Service Bulletin

Bulletin Number: **SB 22-0015-MH-1MBTU**

Subject: Maxi Heat T-Map sensor relocation

Product Line: Maxi Heat 1MBTU

Example A: The sensor was mounted to the top side of the rear quarter panel above the control panel. If your unit has the sensor in this location you can use kit 124435 to complete the update.

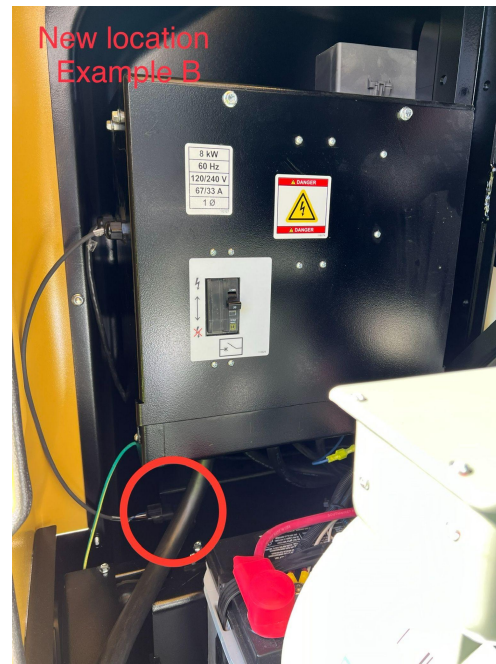
Example B: The new location of the T-Map is underneath the main breaker box. The sensor will mount to a new bracket that comes in kit 124435

Relocate the T-Map sensor from the original location to the new designated area. Kit 124435 will provide the parts and instructions for the update of the T-Map. Page 2 provides an example of the original location and the new location of the sensor. Units with T-Map's in the original location will operate and work correctly; the kit is an optional upgrade.
